P 520111

ON-SITE SEWAGE DISPOSAL SYSTEM HOWARD COUNTY HEALTH DEPARTMENT BUREAU OF ENVIRONMENTAL HEALTH

ADDRESS: 13657 Nichols Drive PROPERTY OWNER: James Smith

TRENCHES:	Trench to be _____ feet wide. Inlet _____ feet below original grade. Bottom maximum depth _____ feet below original grade. Effective area begins at _____ feet below original grade. _____ feet of stone below distribution pipe.
LOCATION:	
PURPOSE:	Existing septic system has failed. Call for inspection when ground is opened so sanitarian can recommend repair.

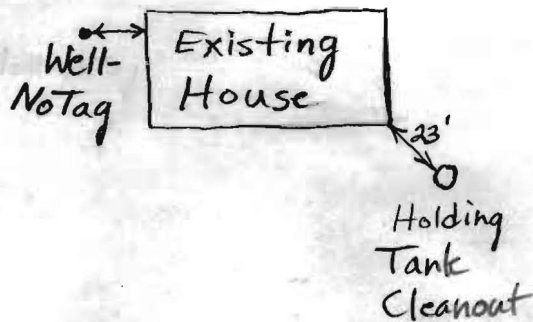
*Aeration Required With
Low Pressure Dosing
Maximize Use of Area*

PRE-CONSTRUCTION 4/5/04 Found enough area for one system at location of holes C and D. Must locate property line before INSTALLATION a system can be configured. See the perc. test sheet for hole locations. **BB**
